Access Compliance Report

Public Rights-of-Way

Intersection ID: 22436	Main Street: CHADMORE SOUTH DR	Cross Street: WILBY HOLLOW DR	Location:	N
ADA ID: 1E4DF8411684	Ramp Type: PerpDiag	Initial Pass/Fail: Fail	Overall Compliance: No	Severity Score: 12.5
Codes/Mitigation Info/Possible Solution		Field Measurements/Component Compliance

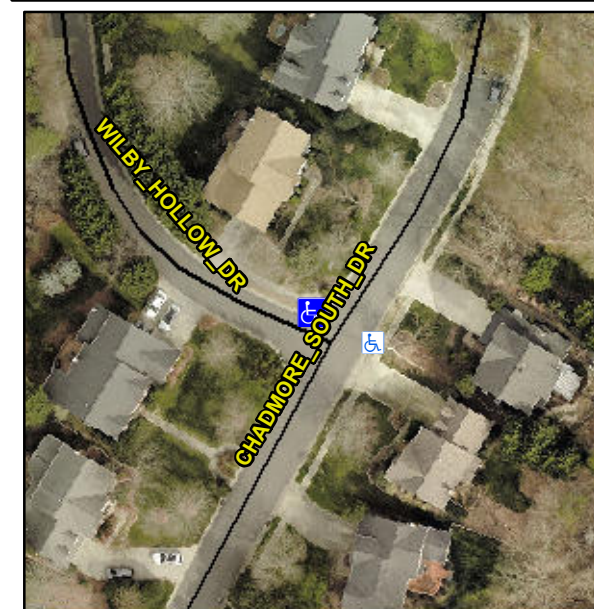
Not Found, R304.5.3

Compliance	Description	Data	Compliance	Description	Data
N/A	Ramp Length (in)	43.0	Yes	Ramp Slope (%)	5.4
Yes	Ramp Width (in)	48.0	No	Ramp XSlope (%)	5.2
N/A	Flare Type LT	N/A	N/A	Flare Type RT	N/A
N/A	Flare Slope LT (%)	N/A	N/A	Flare Slope RT (%)	N/A
N/A	Flare Traversable LT?	N/A	N/A	Flare Traversable RT?	N/A
N/A	Landing Length (in)	N/A	N/A	DWS Provided?	N/A
N/A	Landing Width (in)	N/A	N/A	DWS Contrast?	N/A
N/A	Landing Slope (%)	N/A	N/A	DWS Length (in)	N/A
N/A	Landing X Slope (%)	N/A	N/A	DWS Full Width?	N/A
N/A	Landing Curb? (Y/N)	N/A	N/A	DWS Offset (in)	N/A
N/A	Shared Landing?	N/A			
N/A	Gutter Ponding?	N/A	N/A	Gutter Slope (%)	N/A
N/A	Gutter Lip Ht (in)	N/A	N/A	Gutter X Slope (%)	N/A
N/A	Painted X Walk1?	No	N/A	Painted X Walk2?	No
	X Walk 1 Direction	To SW		X Walk 2 Direction	To SE
N/A	X Walk 1 Width (in)	N/A	N/A	X Walk 2 Width (in)	N/A
	X Walk 1 Slope (%)	1.5		X Walk 2 Slope (%)	5.7
	X Walk 1 X Slope (%)	6.1		X Walk 2 X Slope (%)	0.1

Remove & Replace Curb Ramp With Two New Directional Ramps or Equivalent.
